UNITED STATES PATENT AND TRADEMARK OFFICE

APPLICATION NO.	FILING DATE	FIRST NAMED INVENTOR	ATTORNEY DOCKET NO.	CONFIRMATION NO.
10/561,532	12/19/2005	Ronald Dekker	NL02 1153 US	9985

Office Action Summary	Application No. 10/561,532	Applicant(s) DEKKER ET AL.	
	Examiner Michael B. Shingleton	Art Unit 2815

DETAILED ACTION

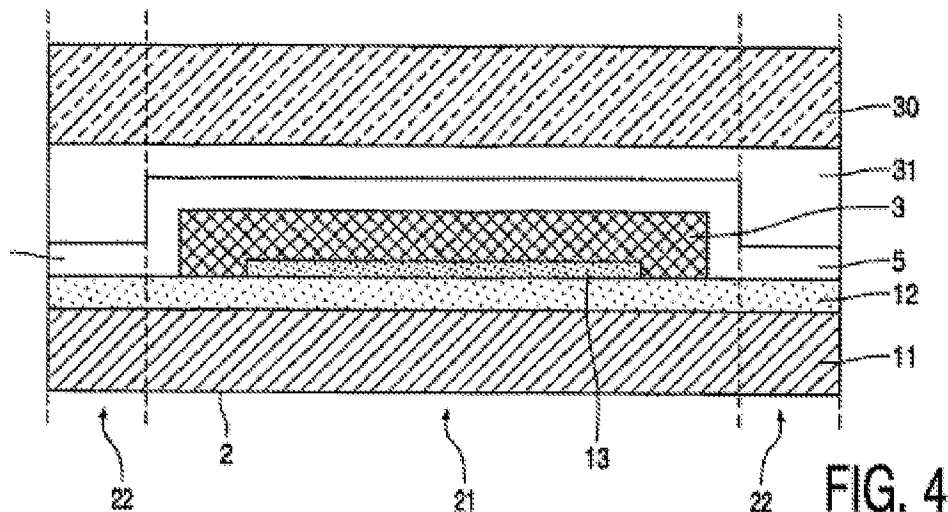
1. Page 8 of the specification states:

The thinning of the substrate is done in two steps, in the first of which the base layer 13 is grinded, after which it is etched with a KOH solution. Herein the oxidic layer 12 acts as an etch-stop layer.

Above is Figure 4 of the instant application.

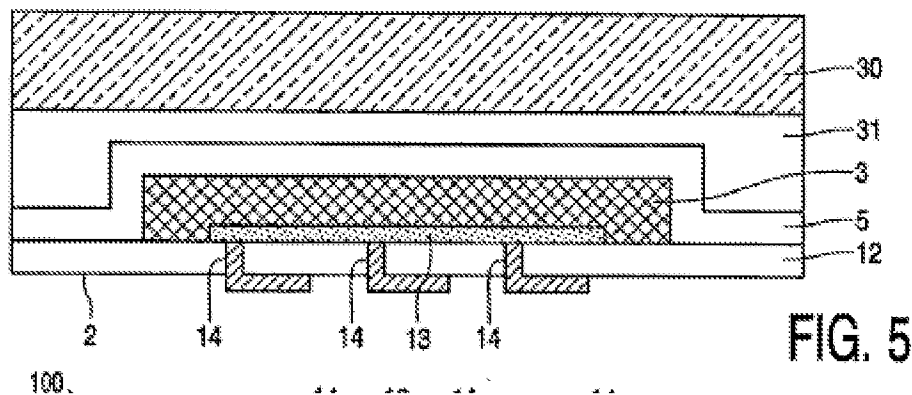
The specification clearly is not written in "full, clear, concise, and exact terms" as required by 35 USC 112 first paragraph because with the base layer 13 being covered by layer 3 and layer 12 such that no part of layer 13 is exposed as shown in Figure 4 how can the base layer 13 be grinded as required by the original disclosure??? Figure 5 showing the result after the grinding of the base layer 13 shows that base layer 13 is not grinded.
